# HISTORIC AND DESIGN REVIEW COMMISSION

October 19, 2022

**HDRC CASE NO:** 2022-402  
**ADDRESS:** 918 DAWSON ST  
**LEGAL DESCRIPTION:** NCB 1370 BLK 2 LOT 13 14  
**ZONING:** RM-4 CD, H  
**CITY COUNCIL DIST.:** 2  
**DISTRICT:** Dignowity Hill Historic District  
**APPLICANT:** Evelyn Ramirez/HAWKINS JAMES C  
**OWNER:** Evelyn Ramirez/HAWKINS JAMES C  
**TYPE OF WORK:** Construction of two, 2-story residential structures and construction of an addition to a rear accessory structure, exterior modifications, site modifications, driveway installation  
**APPLICATION RECEIVED:** October 03, 2022  
**60-DAY REVIEW:** Not applicable due to City Council Emergency Orders  
**CASE MANAGER:** Edward Hall  
**REQUEST:**

The applicant is requesting a Certificate of Appropriateness for approval to:

1 SITE PLAN

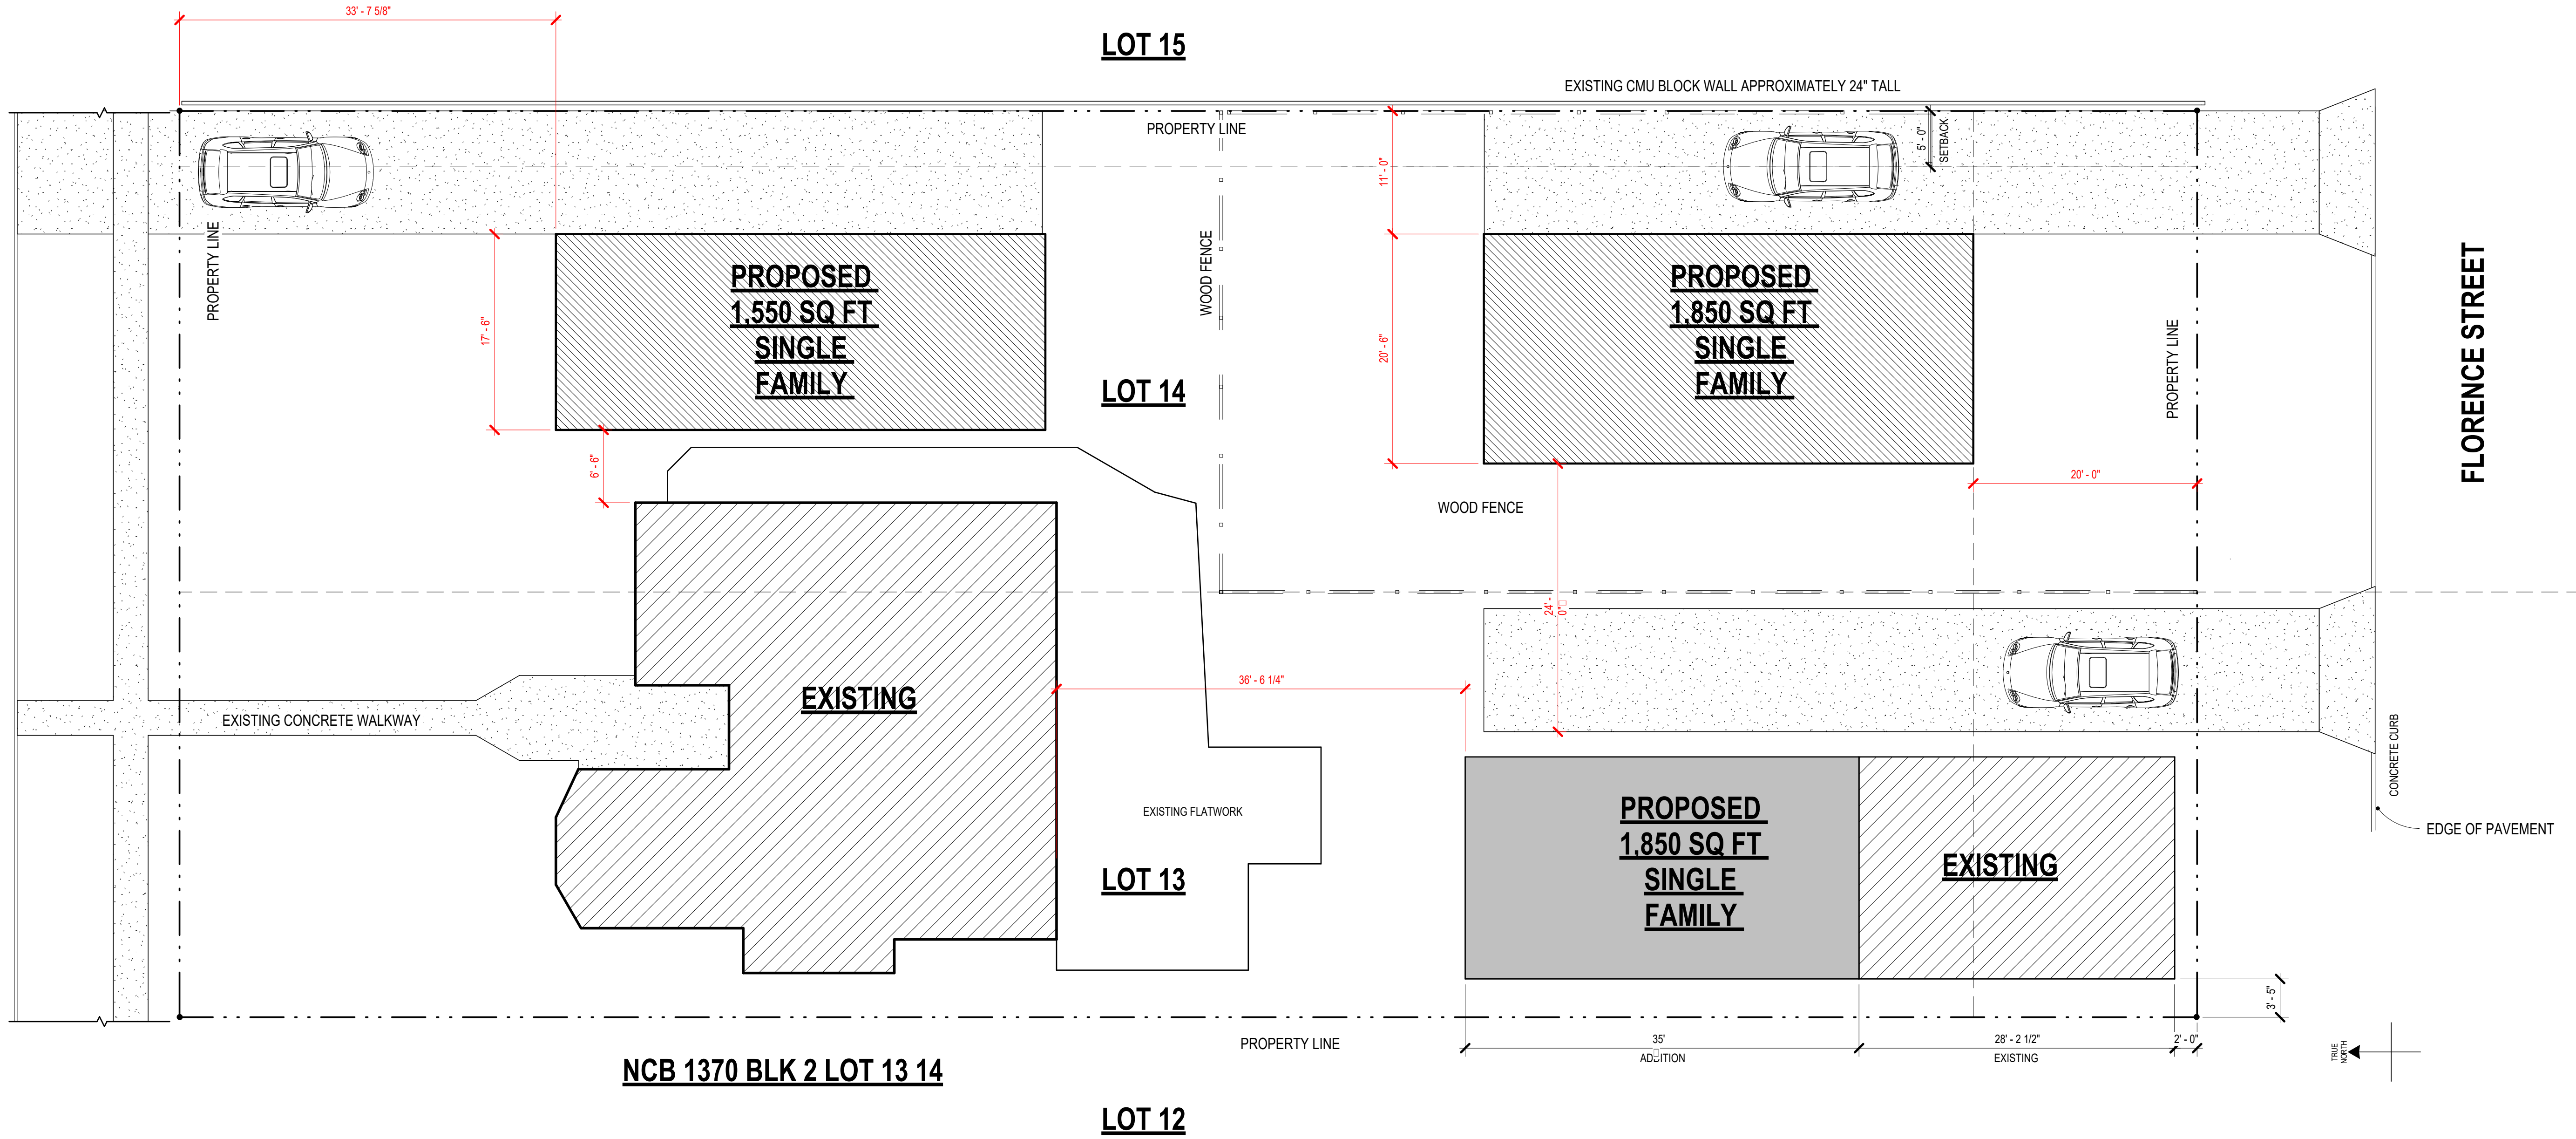
JC: The site plan should include all site elements; fencing, landscaping elements, parking elements, walkways, etc.

JC: Questions about gravel driveway elements, and landscaping. How will the gravel be maintained? Will other landscaping elements be included?

MF: Site plan will be updated to accurately note site conditions and building location.
